ADDENDUM 02

DLR GROUP
421 SW 6th Avenue, Suite 1212
Portland, OR 97204
Tel (503) 274-2675
Fax (503) 274-0313

September 4, 2019

ELECTRICAL SITE PLAN
ELEMENTARY SCHOOL #28
HILLSBORO SCHOOL DISTRICT

SHEET E1.0 – ELECTRICAL SITE PLAN

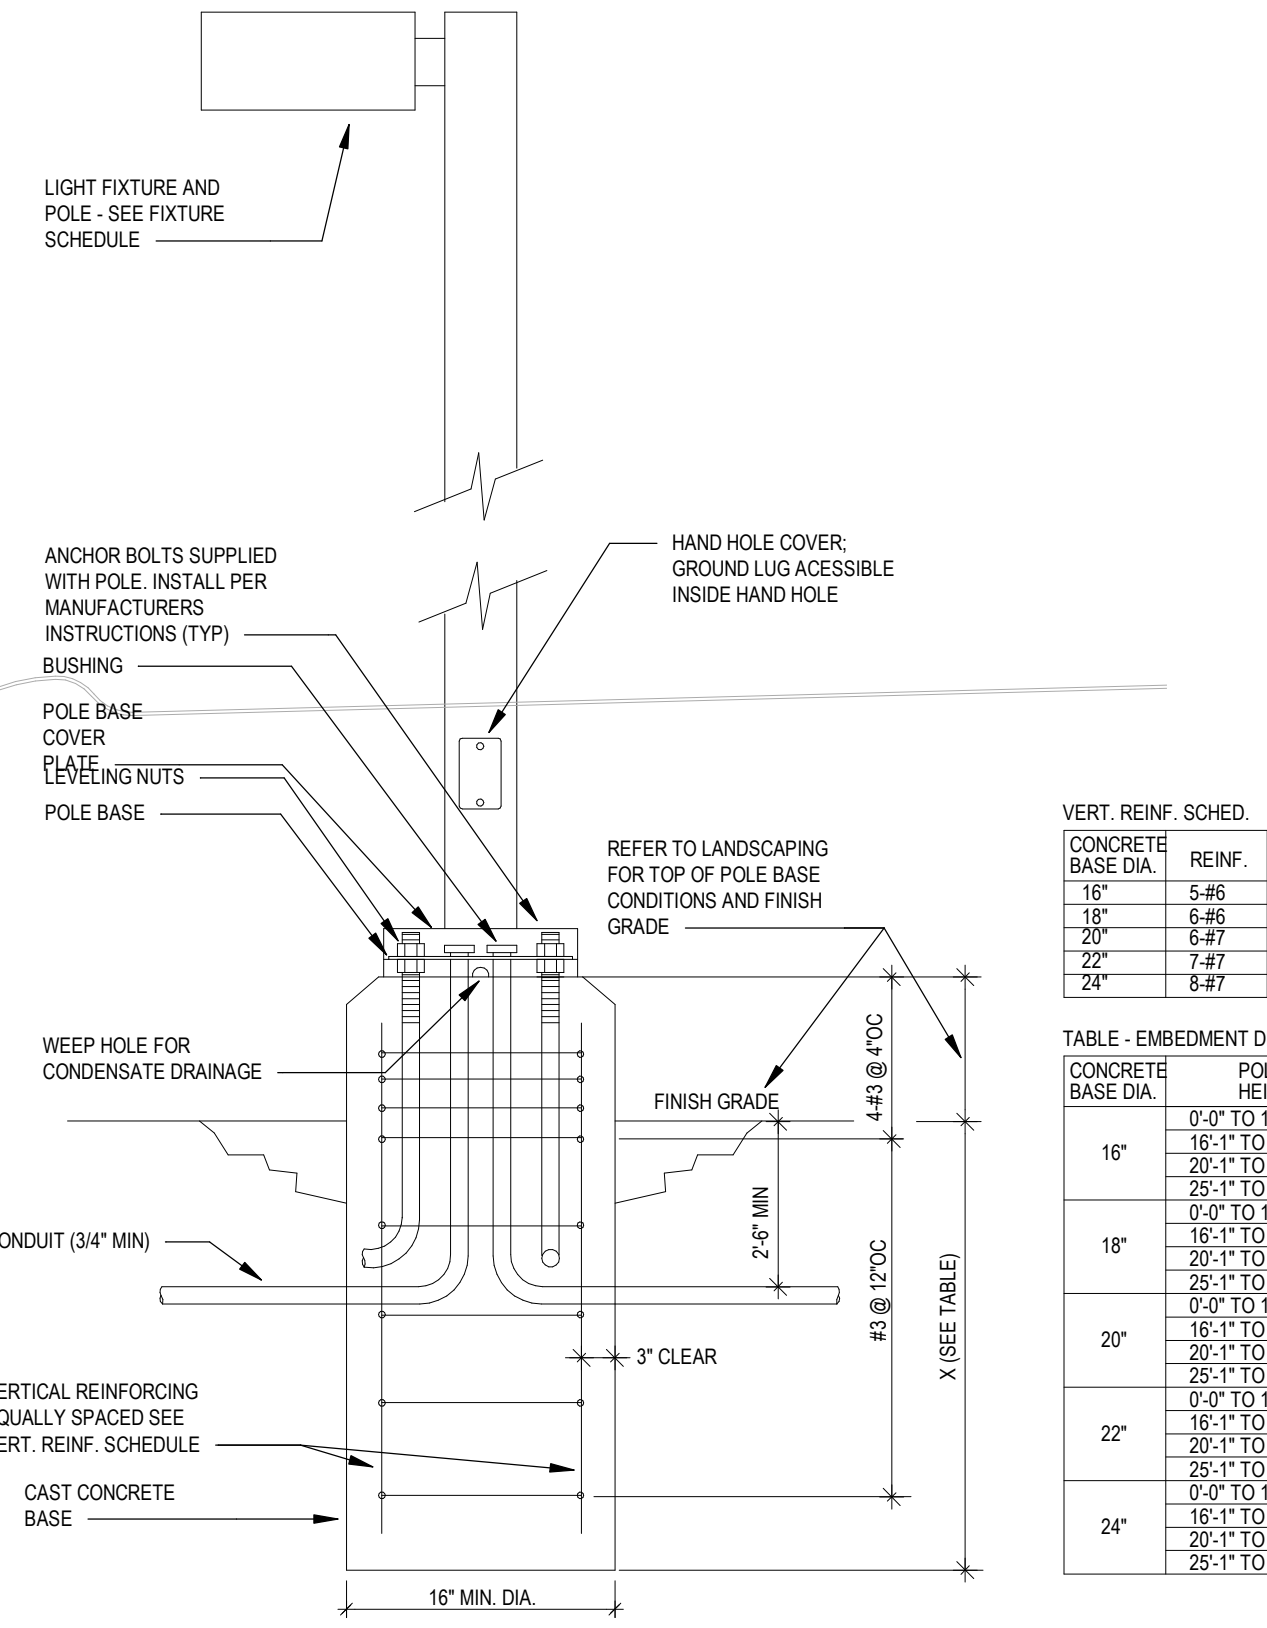
- ITEM NO. 1 SHEET E1.0 – ELECTRICAL SITE PLAN
- A. Edited model number and description for light fixtures SL1 and SL2.
B. Revised note 3 to be not used.
- ITEM NO. 2 SHEET E1.2B – LIGHTING PLAN, LEVEL 2 - AREA B
- A. Revised note 6 to be labeled note 7.
B. Added note 7 and description .
- ITEM NO. 3 SHEET E5.1 – ONE-LINE DIAGRAM
- A. Revised fuse, feeder, disconnect, and breaker size for elevator connection.
B. Modified model number of item in note 7.
- ITEM NO. 4 SHEET E7.1 – ELECTRICAL SCHEDULES
- A. Modified model number of fixture H1.

11	Electrical	E1.0	The exterior site lighting fixture schedule on this sheet shows Type 'SL1' & 'SL2' fixtures as being provided by PGE option A. These pole lights do not appear to be street lighting. Question: Are Type 'SL1' & 'SL2' fixtures provided by PGE..? If these are not provided by PGE are the fixture/pole Types correct as shown...?	Sope has been updated. Electrical contractor to be responsibel for fixtures. Changes noted in addendum 2.

SITE LIGHTING FIXTURE SCHEDULE					
Fixture Type	Manufacturer	Model No.	Electrical	Mounting	Description
SL1	LEOTEK	GCM2-40H-MV-NW-3R-XX-850	120-277V/135 VA	POLE	SITE POLE LIGHT FIXTURE, MOUNT ON 20' POLE
SL2	LEOTEK	GCM2-40H-MV-NW-4-XX-850	120-277V/135 VA	POLE	
SP2	LITHONIA	DSXPG LED 30G 1200 40K TSM MVOLT SRH PIRH	120-277V/100 VA	POLE	PEDESTRIAN WALKWAY LIGHTING, 4000K, TYPE 2, 4000 LUMENS
HL2	LITHONIA	DSXPG LED 30G 1200 40K TSM MVOLT SRH PIRH	120-277V/107 VA	COVERED PLAY	
FL1	MUSCO	TLC LED 1150 5700K 75 CRI	120-277V/1150 VA	POLE	TLC LED 1150, 5700K, 75 CRI, 121,000 LM, MOUNT ON 70' POLE, 5 LUMINAIRES PER POLE
SF1	HYDREL	M840 QS A 12 LED WH141K MVOLT MFL FLC 348	120-277V/12VA	FLUSH

1. PROVIDE FIELD LIGHTING AS DESIGNED BY MUSCO LIGHTING. CONTACT TIM BUTZ AT MUSCO LIGHTING FOR DRAWINGS. REQUIREMENTS: PROVIDE CONNECTION TO MUSCO CONTRACTOR MOUNTED ON EACH POLE.
2. NOT USED, AD-2
3. NOT USED, AD-2
4. PROVIDE DETECTOR ASSEMBLY AND REDUCED PRESSURE BACKFLOW ASSEMBLY. COORDINATE EXACT POSITION AND INSTALLATION WITH CIVIL REQUIREMENTS.
5. REFER TO TELECOM SHEET T501 DETAIL 1.
